IOGP S-560

REDLINE

Version 3.0 to Version 2.0

Supplementary Specification
to IEC 61439-1 and IEC 61439-2
for Low-voltage Switchgear and
Controlgear

Figure HH.1 – Communications interface block diagram

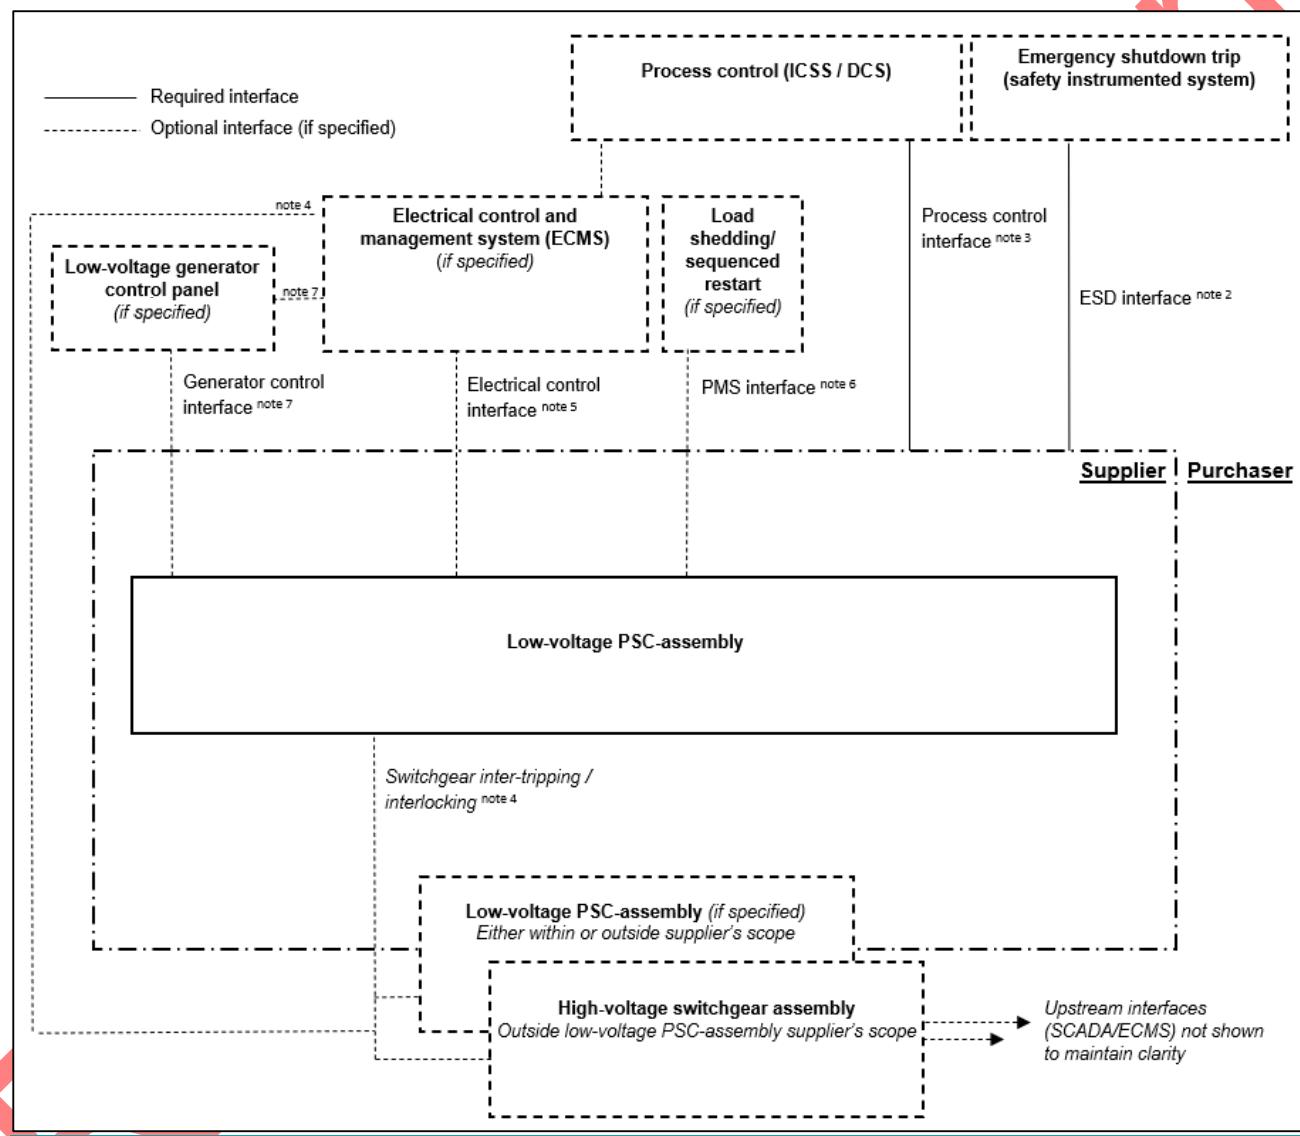
[Add new Figure HH.1](#)

Note 1 This figure is for illustrative purposes only as control system integration topologies are user/project specific. This figure is not intended to assign any IEC 62264-1 hierarchy levels 0 to 4 or imply any demilitarized zone (DMZ) perimeter boundaries.
